# BOARD OF ZONING APPEALS (BZA) CONDITIONAL USE PERMIT APPLICATION

### Horse Power Farms

Phase 2 – remaining site build out

February 10, 2021

EXTERIOR ELEVATIONS - BUILDING 5

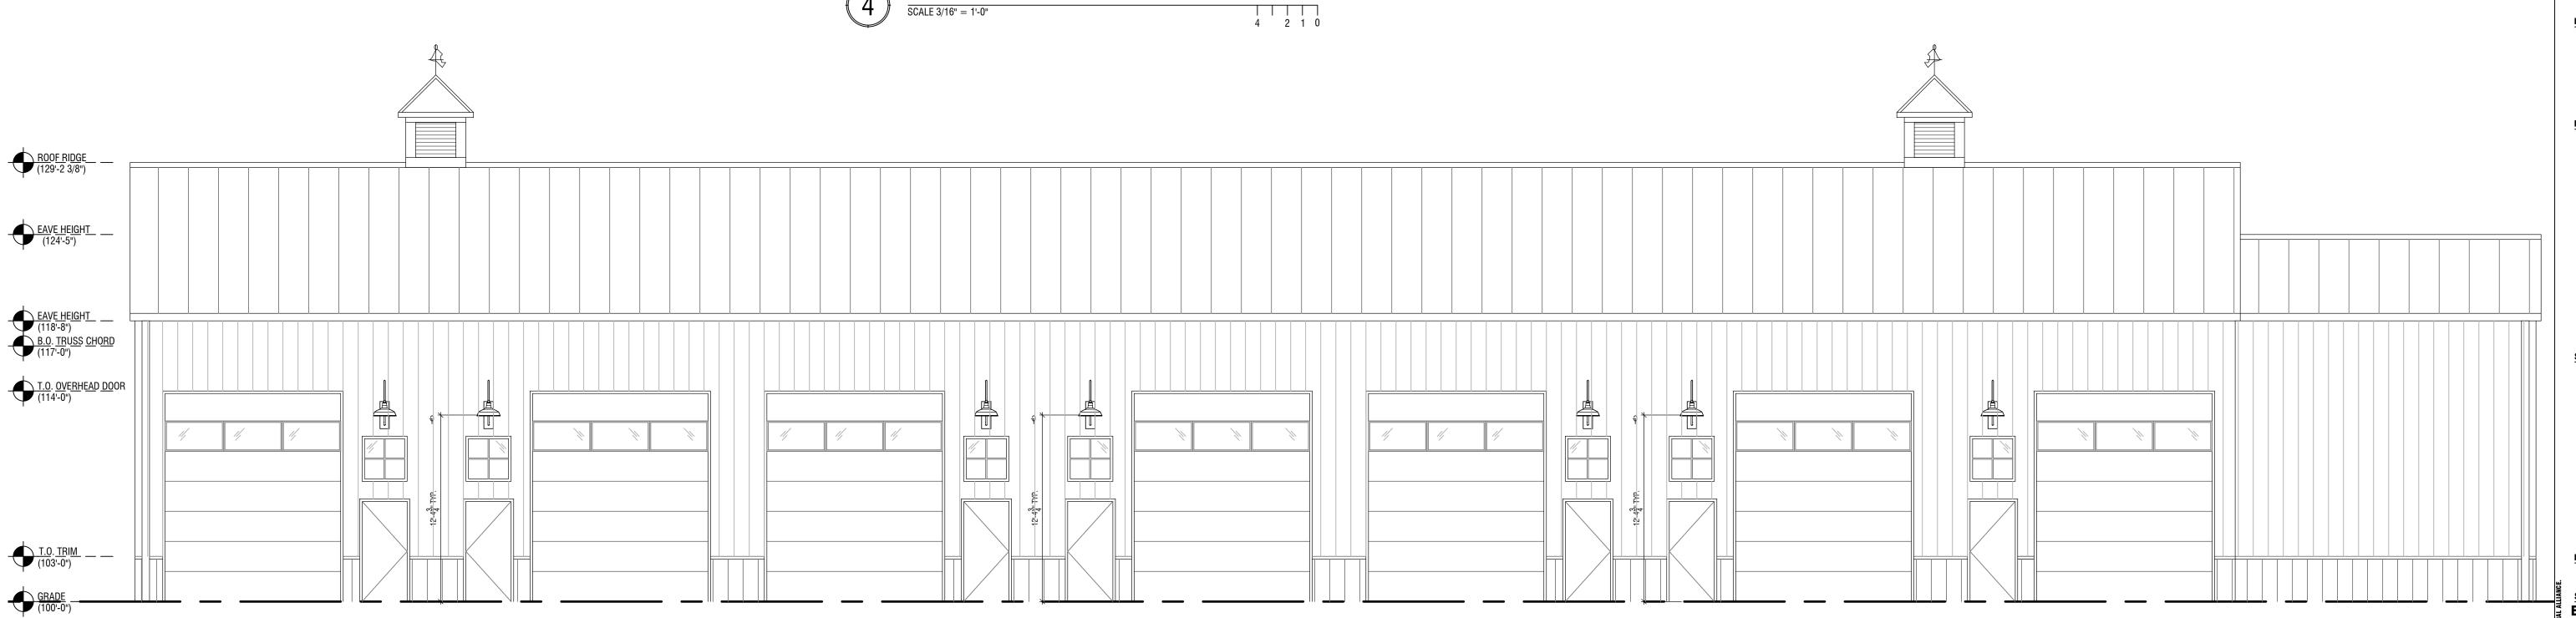
Could there be an opportunity to introduce a shed dormer on the elevations that face each other? This could provide additional daylighting and help break up the extensive roof.
